ARKANSAS POWER & LIGHT COMPANY
POST OFFICE BOX 551 LITTLE ROCK, ARKANSAS 72203 (501) 371-4000

SUBJECT: Arkansas Nuclear One - Units 1 & 2
Docket Nos. 50-313 and 50-368
License Nos. DPR-51 and NPF-6
Additional Information Concerning
Spent Fuel Storage Expansion

Your letter dated January 5, 1983 (ØCNAØ183Ø4) requested additional information concerning the proposed spent fuel storage expansion at Arkansas Nuclear One (ANO). This submittal is in response to that request.

QUESTIONS RELATING TO THE STRUCTURAL AREA

Arkansas Unit 1, Linear Model Geometry Plot, (11 x 12) Rack

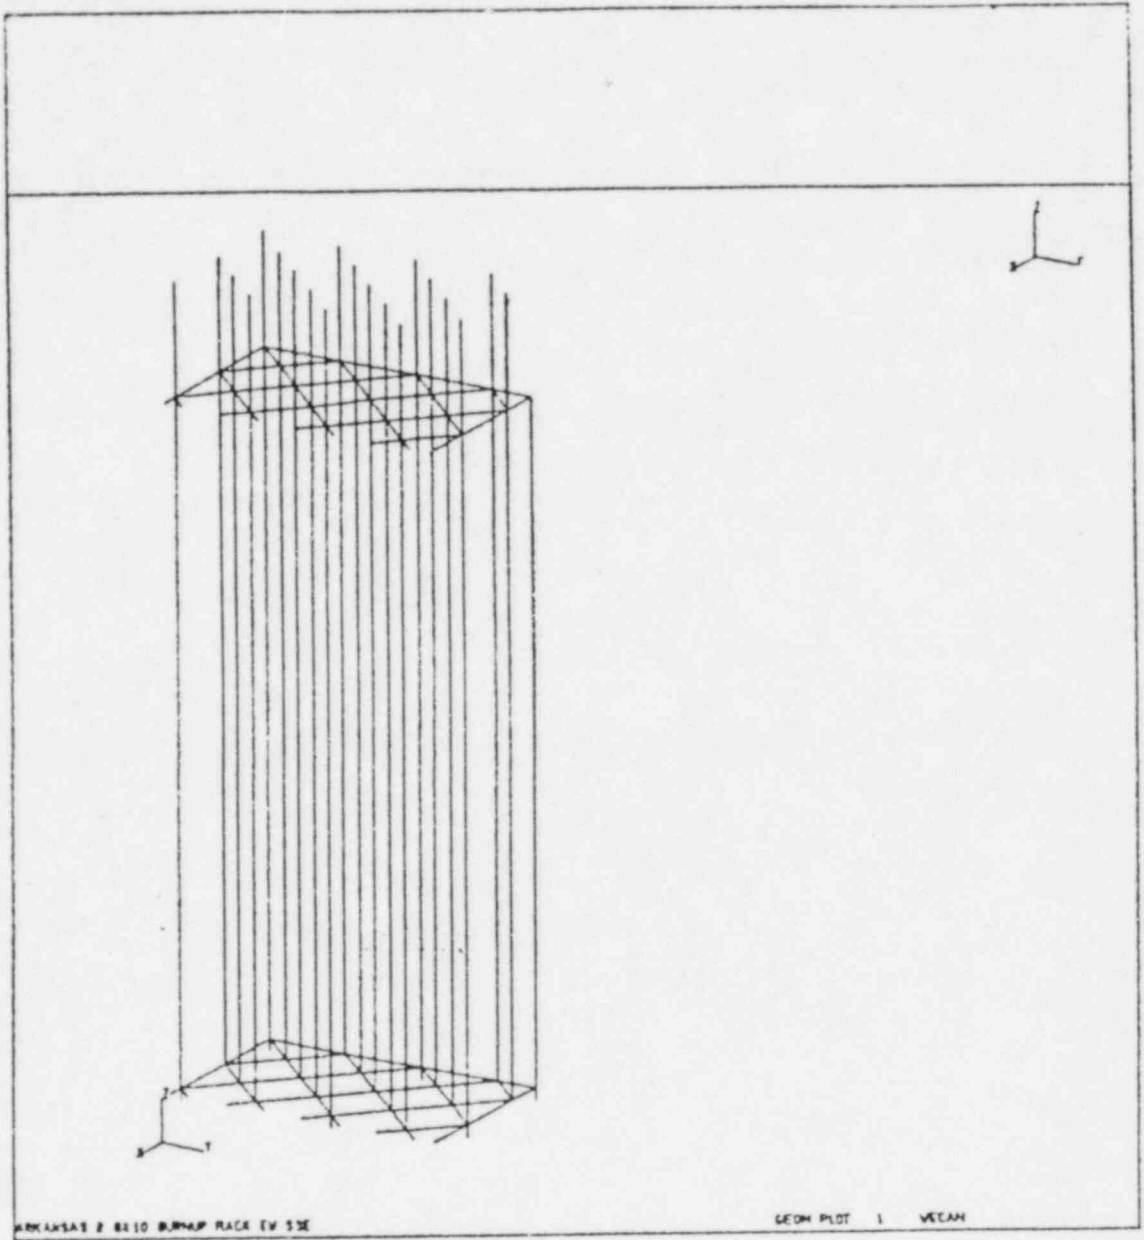
Provide key calculations and results of the seismic analysis. Include sketches of the mathematical model and discuss the method of modeling potential rack-to-rack and rack-to-pool interaction due to sliding and/or tipping, if any.

The linear model, shown in the following sketch, is a three-dimensional finite element representation of a rack assembly. The structural properties of the individual beams for the cells, grids, support pads, etc., are calculated from the effective sections. The mass is composed of the structural masses of rack, fuel assembly, and control rod assembly, the water inside the cells, and the hydrodynamic mass between the rack and pool wall. The structural mass and water inside the cells are distributed on the cells, and the hydrodynamic mass between the rack and pool is input with a mass matrix element. The model is constructed for half the rack and divided at the line of symmetry with appropriate boundary conditions. A geometry plot is included to show the construction of the model.

The structural properties of a single cell representation, which are used for the nonlinear model, are obtained from the results of the detail model. The results of the single cell model computer run, frequency and mode shape, are compared with that of the detail model to insure correct structural representation.

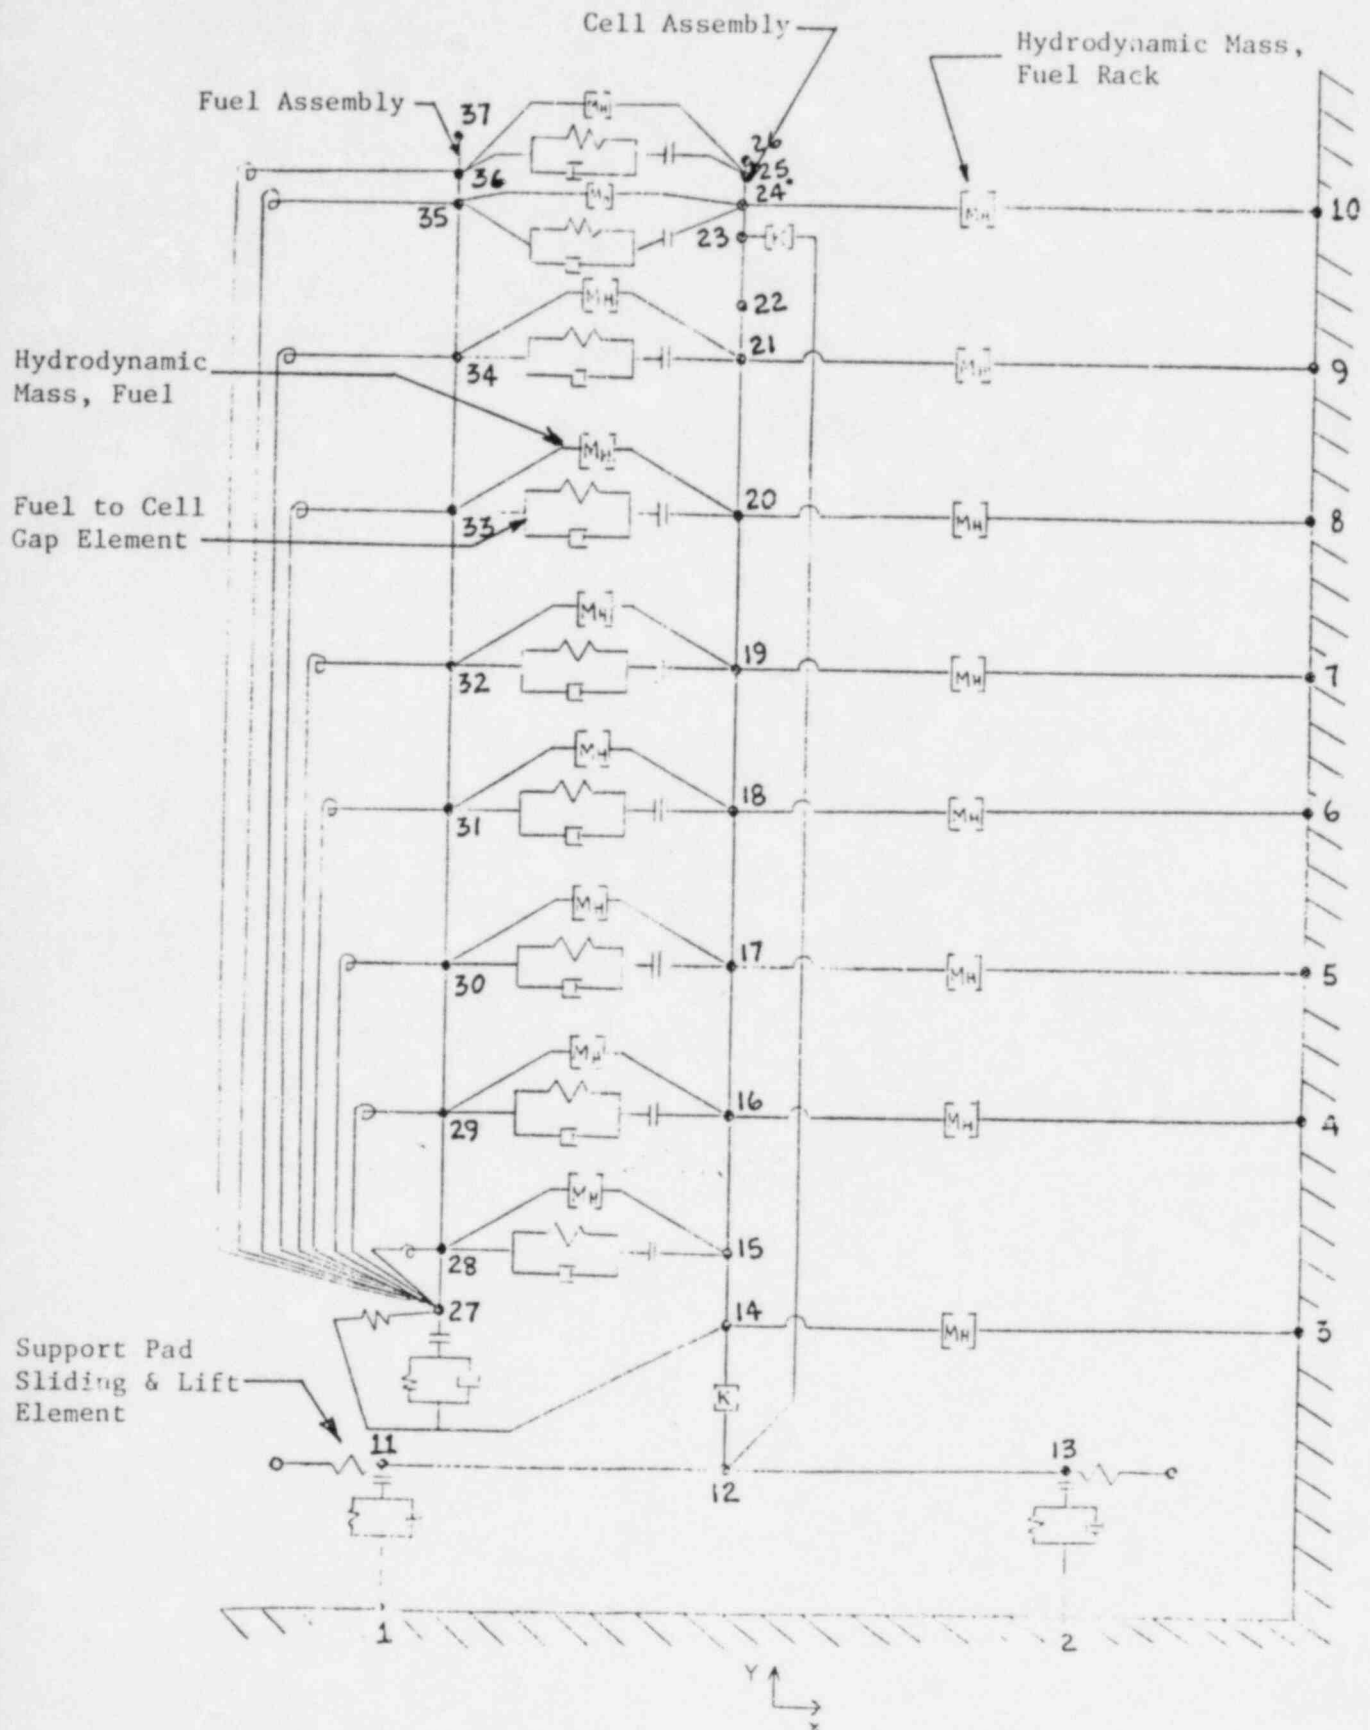
The geometry plot, shown in the following sketch, is the single cell finite elements representation of the nonlinear mathematical model. The structural properties of the rack components are represented by six different finite elements. These elements and their identification number (ITYPE) are listed below:

The three-dimensional beam element (STIF 4) is a straight uniform cross section element with tension-compression, torsion, and bending capabilities. This element is used to model the fuel beam, cell beam, and rack base beam.

The three-dimensional dynamic friction element (STIF 77) is composed of a gap in series with a parallel combination of impact spring and impact damper with a frictional spring orthogonal to the gap. This element is designed to represent two surfaces which may slide relative to each other, and may separate or contact each other. The friction behavior is represented by a friction spring, and the impact behavior is represented by combination of an impact spring and a dashpot in parallel, coupled to a gap in series. The friction spring is along the direction of sliding which is normal to the direction of impact. The classical Coulomb friction is assumed between the sliding surfaces. The friction behavior is simulated by a stiffness method. The friction spring will transmit the shear forces across the surfaces as long as these forces are below the friction limit. Once sliding takes place, a pseudo force is applied to the sliding surface such that the resultant of the force in the friction spring and the pseudo force will represent the friction force. This element is used to model the sliding and or lift off of the support pads and the fuel base.

ARKANSAS NUCLEAR
SPENT FUEL STORAGE FACILITY

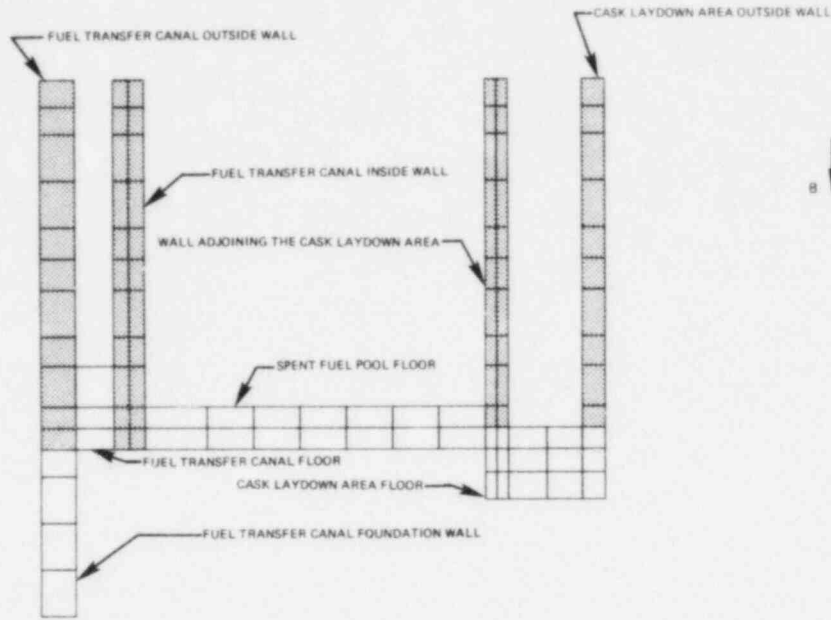
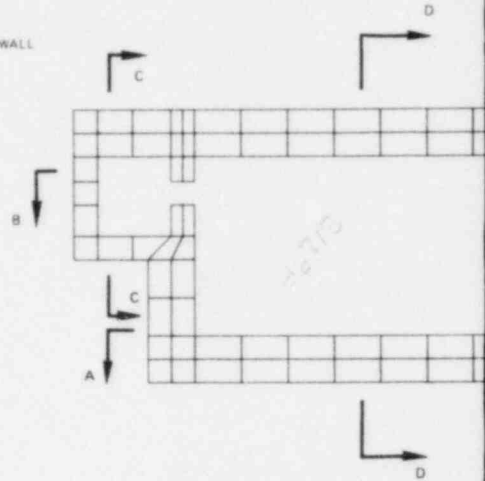
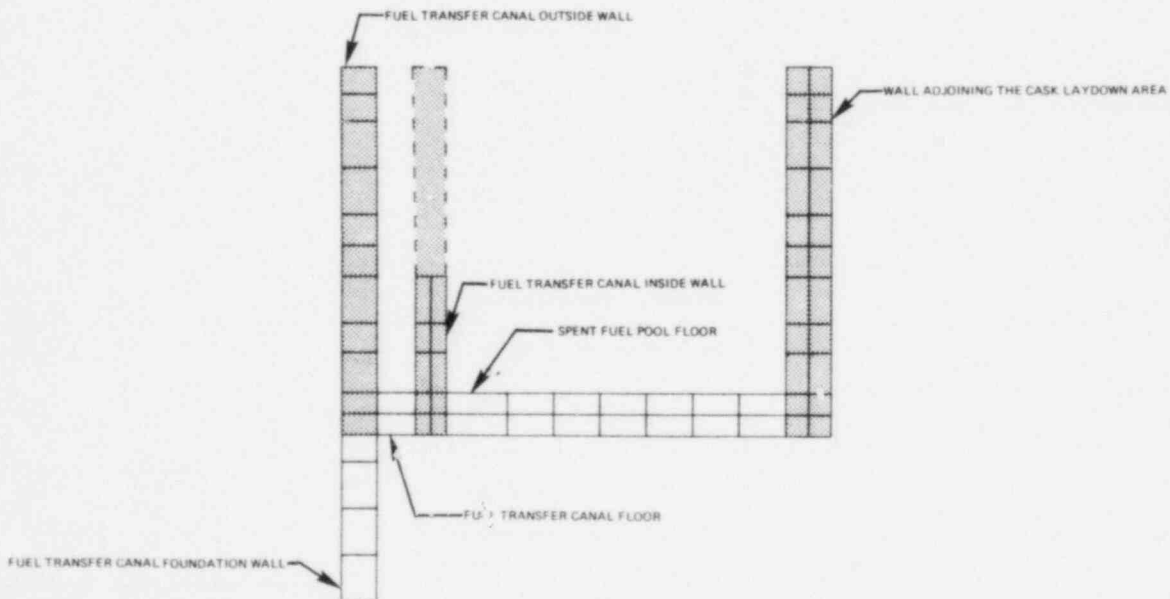
Provide a tabulation of allowable vs. computed stresses for the racks and pool.

Attached are the appropriate Tables and Figures showing computer models for the pool area only.
